PIC10F220/222 Rev. A Silicon Errata

The PIC10F220/222 parts you have received conform functionally to the Device Data Sheet (DS41270B), except for the anomalies described below.

FIGURE 1: TYPICAL DNL AT 2.0V (TESTING AT 7-BIT LEVEL)

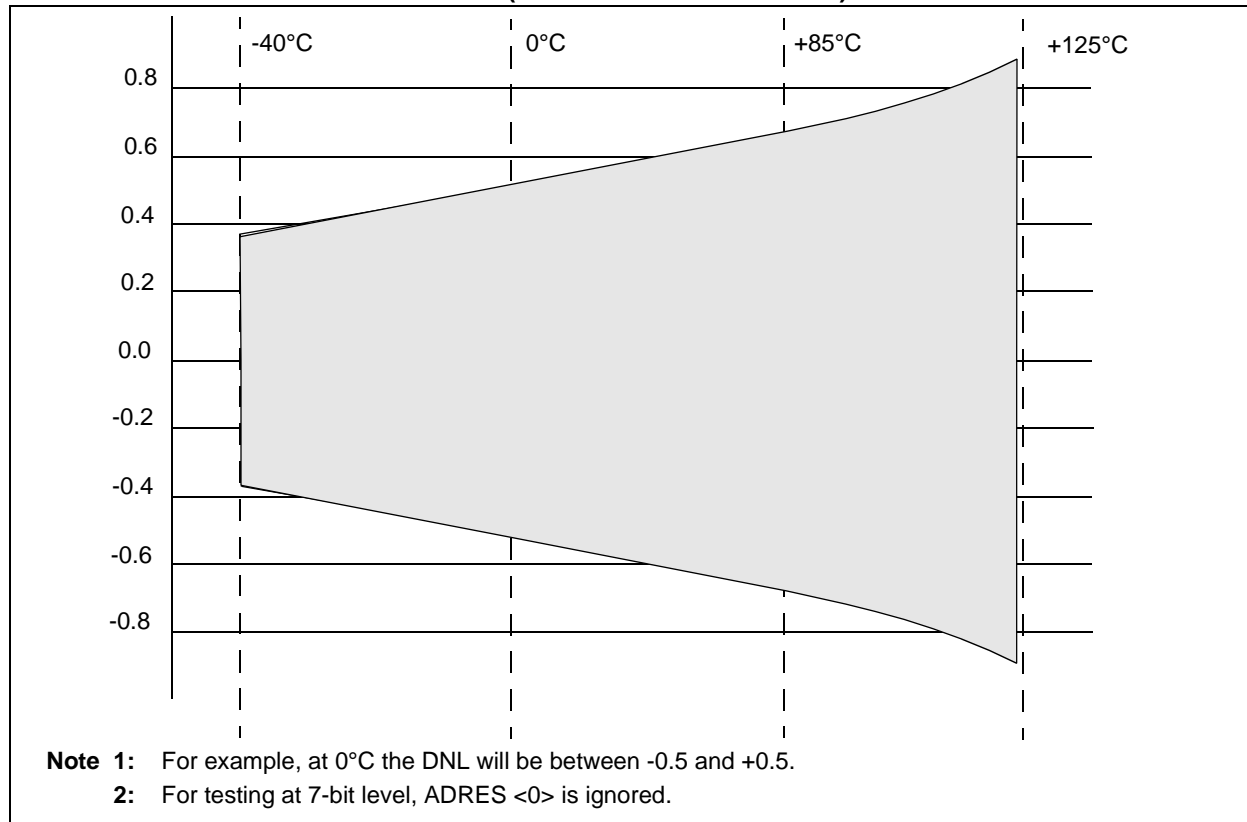
PIC10F220/222 silicon Rev. A1. The A/D Converter does not meet the design target. The specifications listed below in Table 10-6 supersede Table 10-6 in DS41270B.
